RS-01-263

Subject: Additional Electrical Information Supporting the License Amendment  
Request to Permit Uprated Power Operation at Dresden Nuclear Power  
Station and Quad Cities Nuclear Power Station

### **Additional Electrical Information Supporting the License Amendment Request to Permit Uprated Power Operation at Dresden Nuclear Power Station and Quad Cities Nuclear Power Station**

**Sample Coordination Plot for Relay Settings**

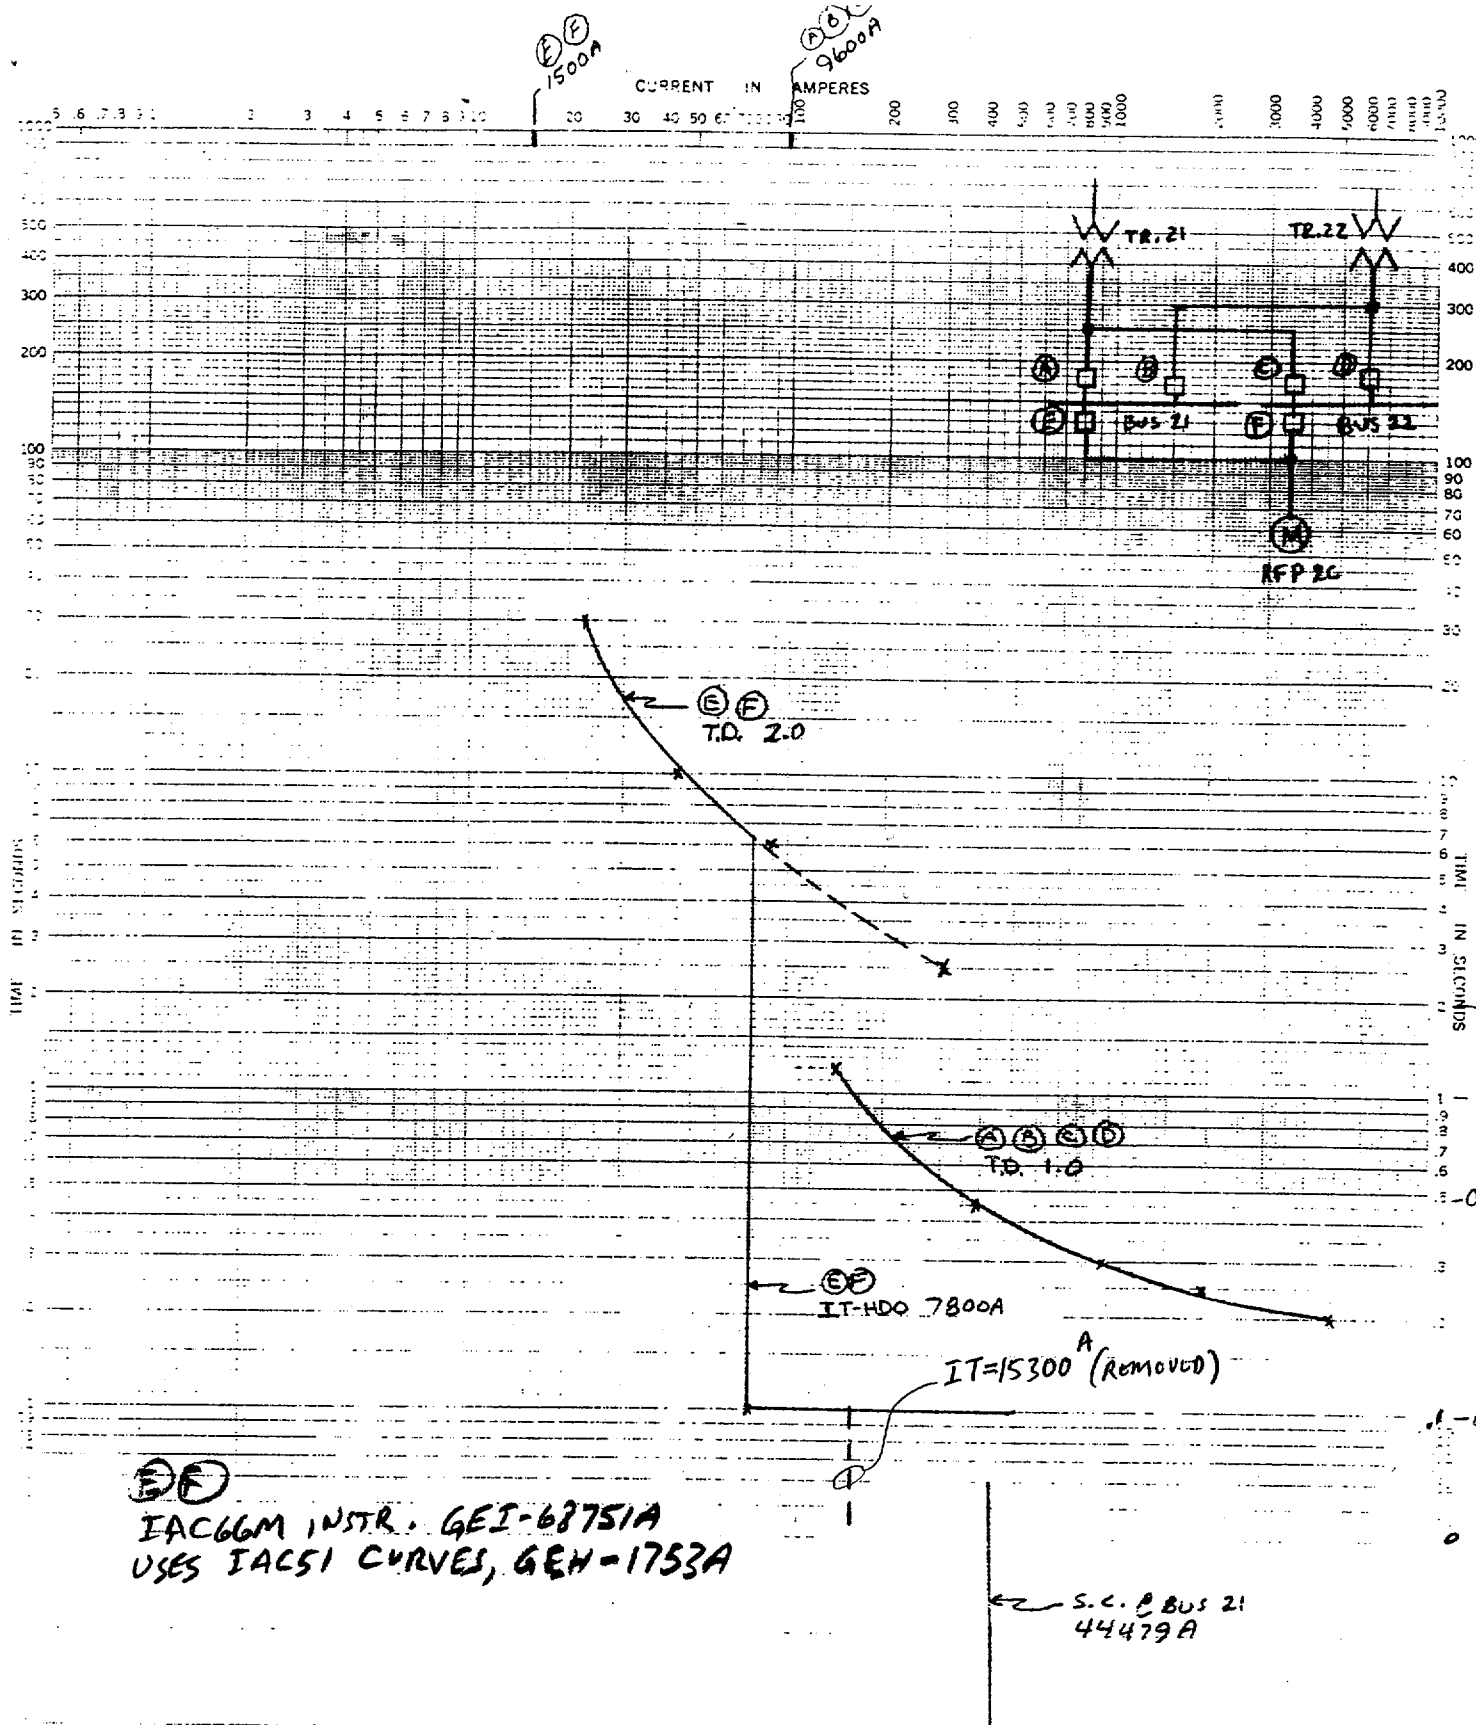
*Provide details concerning the impact of the extended power uprate (EPU) on the scenario in which either the unit auxiliary transformer (UAT) or the reserve auxiliary transformer (RAT) become unavailable, causing the running loads to be transferred to the remaining available transformer. a.) Describe the evaluations that determined the acceptability of the increased running loads and any potential short circuit conditions while in this configuration. Provide manufacturer data for the protective relay and a sample coordination plot for the relay setting to support this determination. b.) Describe the operator actions for responding to this scenario and how they change for EPU.*

The protective relay settings to protect against a short circuit for this scenario were discussed in References 1 and 2. These relays are GE type IAC 66M time overcurrent relays that contain both an instantaneous overcurrent setting and a high dropout setting with a time delay. Manufacturer information for this relay is provided in Attachment B. As described in References 1 and 2, the instantaneous overcurrent relay for the load breakers for buses 21, 22, 31, and 32 for DNPS and buses 11, 12, 21, and 22 for QCNPS will be disconnected, leaving the high dropout feature, which will actuate after a six cycle (i.e., 0.1 second) time delay. Based on ANSI/IEEE C57.12, the UAT and RAT can provide the short circuit current for two seconds without damage. Based on the protection scheme coordination curves, the capability of the 4 kV bus duct to withstand the short circuit current is not affected by the six cycle time delay. Thus, the overcurrent relays still provide adequate protection. The remaining portions of the protective relaying were not changed for EPU. The coordination between the main breaker to the switchgear, the motor feeds, the bus duct capability, and the transformer capability curve is maintained. A sample coordination plot showing the adequacy of the relay settings is provided in Attachment C.
